LAST MINUTE AGENDA INFORMATION II

05/20/09 Regular Meeting

**STAFF REPORT
CITY OF IMPERIAL BEACH**

SUBJECT: PUBLIC HEARING: FERAS "RUSTY" BARGHOUT
(APPLICANT/PROPERTY OWNER)/NICK ALJABI
(ARCHITECT); CONDITIONAL USE PERMIT (CUP 03-03),
DESIGN REVIEW (DRC 03-10), SITE PLAN REVIEW (SPR 03-09) FOR A MIXED DEVELOPMENT WITH THREE RETAIL
COMMERCIAL SPACES AND FOUR RESIDENTIAL UNITS
LOCATED AT 1146 13TH STREET, IN THE C-3
(NEIGHBORHOOD COMMERCIAL) ZONE. MF 641.

REVISED (PARTIAL) SITE PLAN

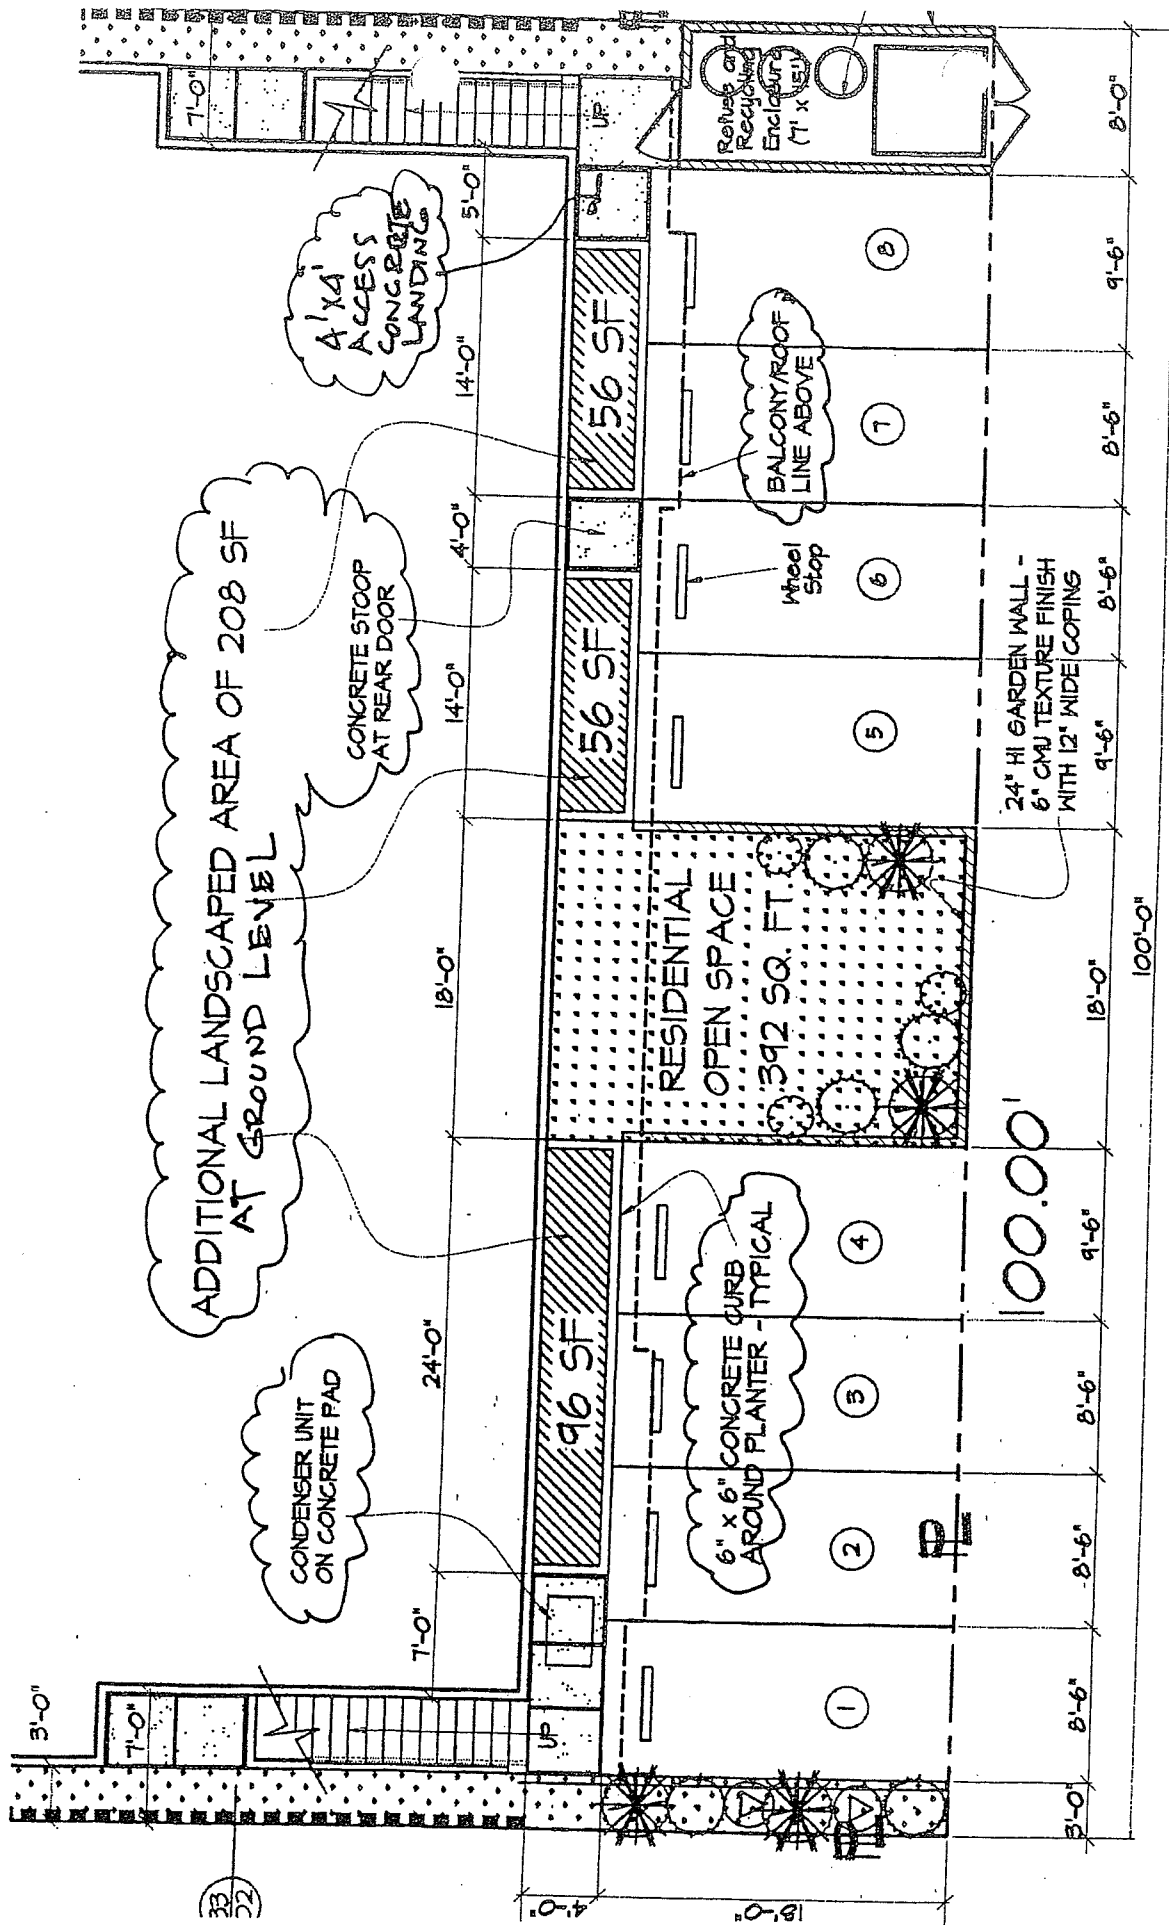
Planter Boxes at 2nd Floor to be removed = 30 + 140 + 30 SQ FT = 200 SQ FT

REVISED LANDSCAPED AREA = (231+103+70+260+307+392+40 Planter Boxes at 2nd Flr) = 1,403 SQ FT
PROPOSED ADDITIONAL LANDSCAPED AREA AT REAR YARD = 96 + 56 + 56 = 208 SQ FT
(SEE REVISED PARTIAL SITE PLAN)
